AGENDA

PLANNING & ZONING COMMISSION REGULAR MEETING WEDNESDAY, JANUARY 10, 2024 - 3:30 PM MCALLEN CITY HALL, 1300 HOUSTON AVENUE CITY COMMISSION CHAMBERS, 3RD FLOOR

PLANNED UNIT DEVELOPMENT FOR CAMPO DE SUEÑOS SUBDIVISION PHASE II

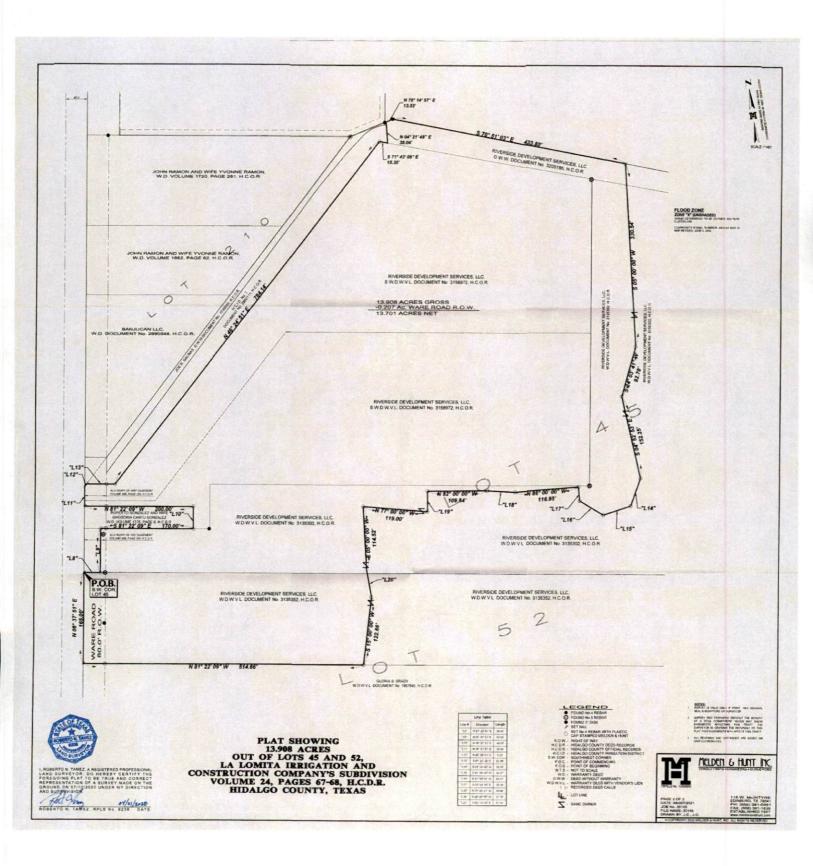
- 1. <u>CONCEPTUAL SITE PLAN</u>: Development and use of the property must comply with the conditional use permit conceptual site plan.
- 2. <u>PERMITTED USES:</u> Permitted uses are uses permitted in the R-1 District for buildings designated as residential. The applicant is proposing single family residences and a common area.
- 3. <u>OFF-STREET PARKING AND LOADING:</u> Parking in compliance with Chapter 134 Article VI, which requires two parking spaces per unit, with one being located beyond the front yard setback. Must provide floor plan with garage to determine if in compliance.

- 4. <u>LANDSCAPING</u>: Each lot requires 10% landscaping in an R-1 zone. Based on the lot area of 1,030,760.28 sq. ft., 103,076 sq. ft. of landscaping is required. Also, 50% of the required front yard must be landscape, including the side yard setback areas. Some lots such as lots 107, 116, 117 may not meet the 50% landscape requirement. A minimum of one tree is required. Must provide front landscaping area and trees to determine if in compliance. Some lots show driveway on one side of the side yard setback, it is not in compliance.

- 5. <u>STREETS AND SETBACKS</u>: Additional 35 ft. right-of-way dedication required along Ware Road. Provide minimum of 50 ft. right-of-way and 40 ft. of pavement width for Emory Avenue. Provide minimum of 50 ft. right-of-way and 32 ft. of pavement for N. 33rd Lane. Setbacks are Front: 20 ft. or greater for easements, except 25 feet for lots 83-86, 91-103 & 139-149 or greater for easements; Rear: 10 ft. or greater or easements; Sides: 5 ft. or greater for easements; Side corner: 10 ft. or greater for easements; and Garage: 18 ft. except where greater setback is required or greater setback applies. An R-1 zone requires a front yard setback of 25 ft. on interior streets. The development is proposing less than 25 ft. of front yard setback, instead proposing a 20 ft. front yard setback for certain lots as mentioned above. The development is proposing 25 ft. of front yard setback for certain lots (Lots 84-85, 93-103, & 143-147). Provide setback lines with building envelope on site plan. A 5 ft. wide minimum sidewalk required on Ware Road and a 4 ft. wide minimum sidewalk required on N. 33rd Street and both sides of all interior street. Must provide sidewalk width dimension on site plan.

- 6. <u>DRAINAGE</u>: During the Campo de Sueños Phase II Subdivision and Campo de Sueños Phase III Subdivision process final drainage detention and design and drainage plan must be submitted and in accordance with City of McAllen Standard Design Guide.

- 8. Owner, Engineer and Surveyor certification and signature block needs to be shown on the PUD site plan. Submitted site plan meets requirements.
- A recorded subdivision plat and PUD site plan is required prior to issuance of building permits. Therefore, Campo de Sueños Phase II Subdivision and Campo de Sueños Phase III Subdivision process must be completed, and recorded together with the site plan.

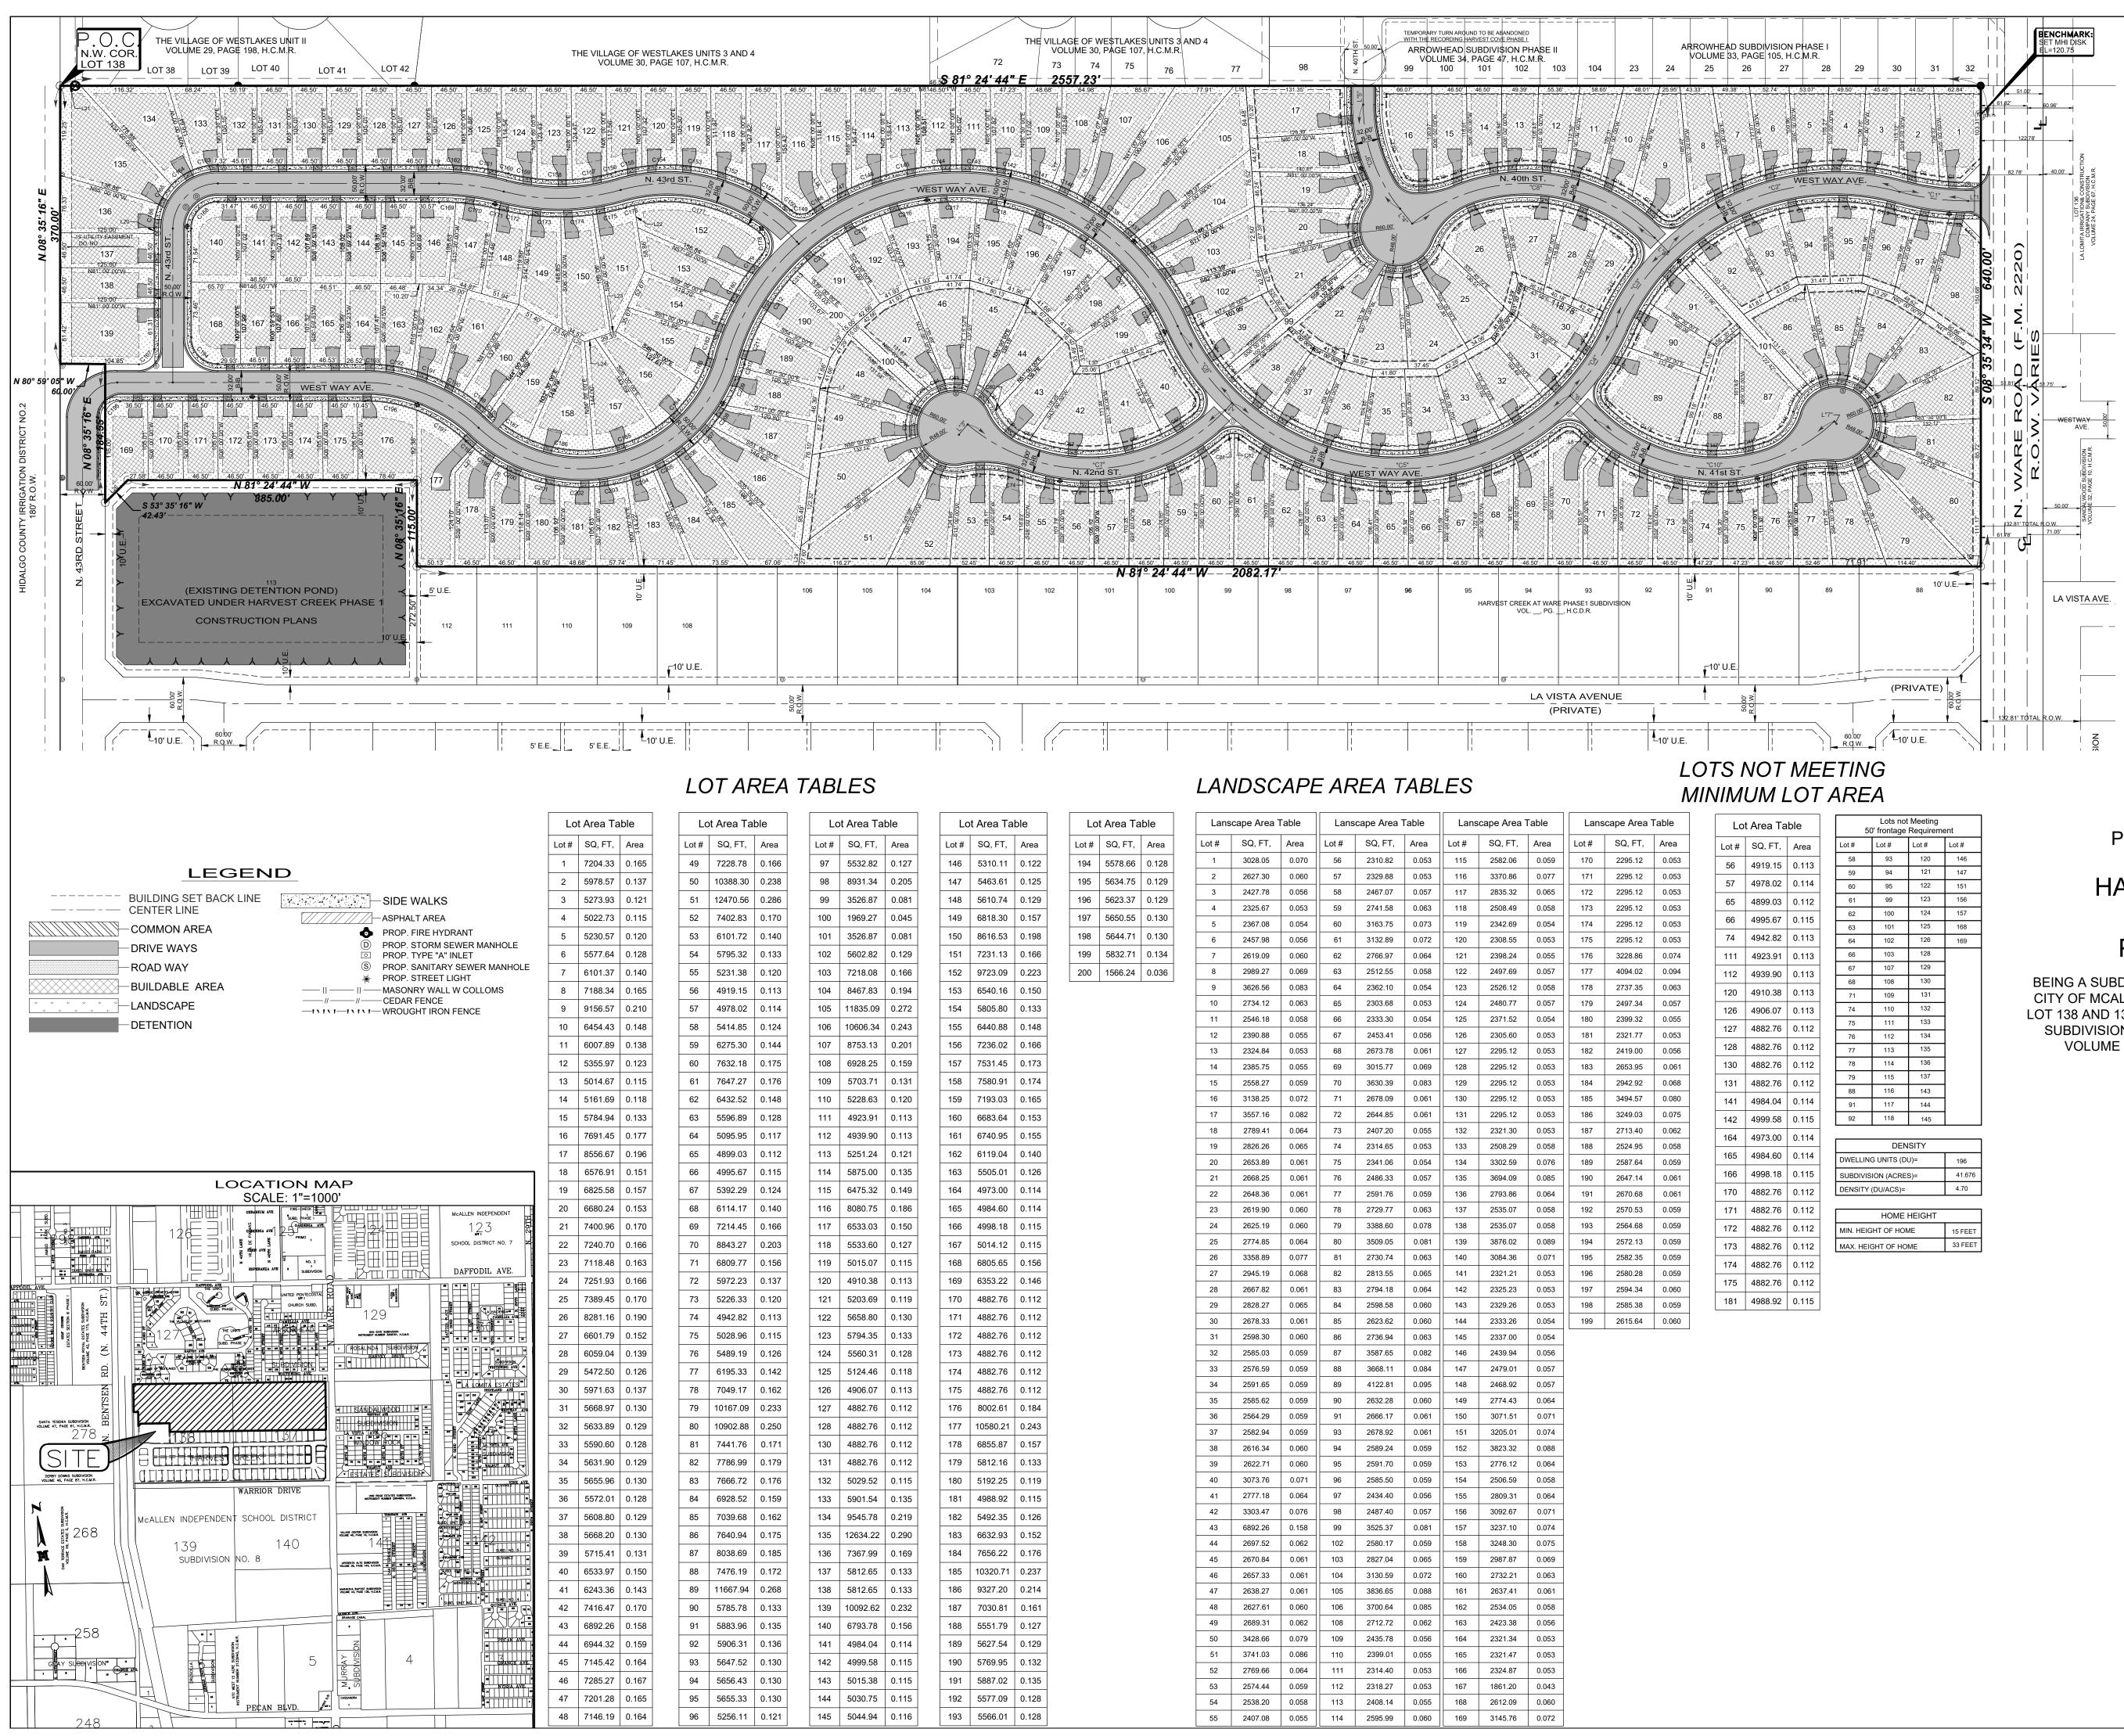
- 1. <u>CONCEPTUAL SITE PLAN</u>: Development and use of the property must comply with the conditional use permit conceptual site plan.
- 2. <u>PERMITTED USES</u>: Permitted uses are uses permitted in the R-1 District for buildings designated as residential. The applicant is proposing single family residences and a common area.

- 3. <u>OFF-STREET PARKING AND LOADING:</u> Parking in compliance with Chapter 134 Article VI, which requires two parking spaces per unit, with one being located beyond the front yard setback. Must provide floor plan with garage to determine if in compliance.

- 4. <u>LANDSCAPING:</u> Each lot requires 10% landscaping in an R-1 zone. Based on the lot area of 813,570.12 sq. ft., 81,357.012 sq. ft. of landscaping is required. Also, 50% of the required front yard must be landscape, including the side yard setback areas. Some lots such as lots 48, 50-52, 186 may not meet the 50% landscape requirement. A minimum of one tree is required. Must provide front landscaping area and trees to determine if in compliance. Some lots show driveway on one side of the side yard setback, it is not in compliance.

5. <u>STREETS AND SETBACKS</u>: Providing a of 60 ft. right-of-way for North 43rd Street. Provide minimum of 50 ft. right-of-way and 32 ft. of pavement for each interior street within the subdivision. Setbacks are Front: 20 ft. or greater for easements, whichever is greater; Rear: 10 ft. or greater or easements; Sides: 6 ft. or greater for easements; Corner: 10 ft. or greater for easements; and Garage: 18 ft. except where greater setback is required. An R-1 zone requires a front yard setback of 25 ft. on interior streets. The development is proposing less than 25 ft. of front yard setback and instead is proposing 20 ft. of front setback for each lot. Provide setback lines with building envelope on site plan with a 5 ft. wide minimum sidewalk required on Ware Road and a 5 ft. wide minimum sidewalk required on all interior street. Must provide sidewalk width dimension on site plan.

- 6. <u>DRAINAGE</u>: During the Harvest Cove Subdivision Phase I and II process final drainage detention and design and drainage plan must be submitted and in accordance with City of McAllen Standard Design Guide.
